TECHNICAL INFORMATION

No: PRO-01-1/2

Subject: MODIFICATION OF MR-1 FOR NON-STANDARD EQUALIZATION Date: 8-27-85

Figure 1
Playback amp

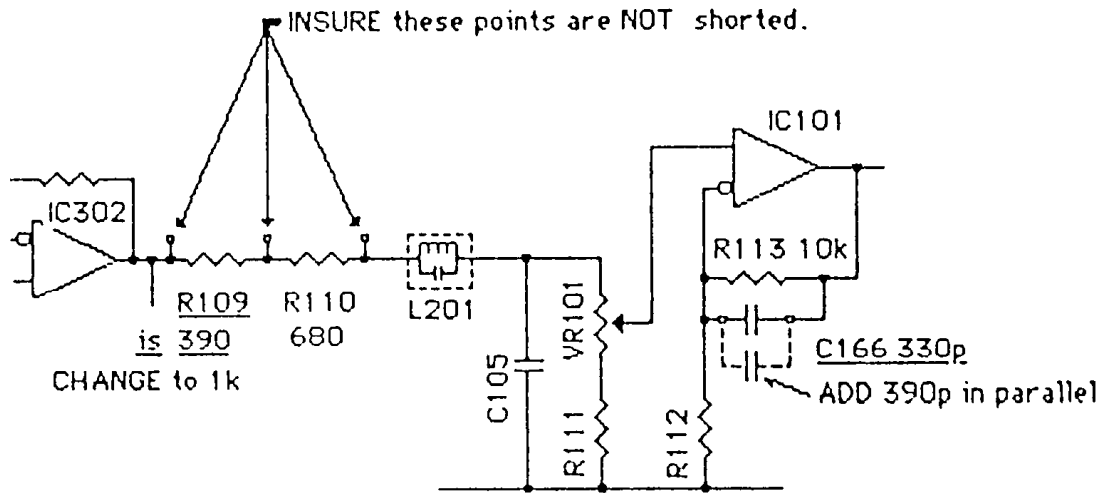
- Step 1: Insure that R109, R209, R110, and R210 are not shorted.
- Step 2: Change R109 and R209 from 390 ohms to 1K ohm.
- Step 3: Add a 390 pf polypropylene capacitor in parallel with C166 and C266.
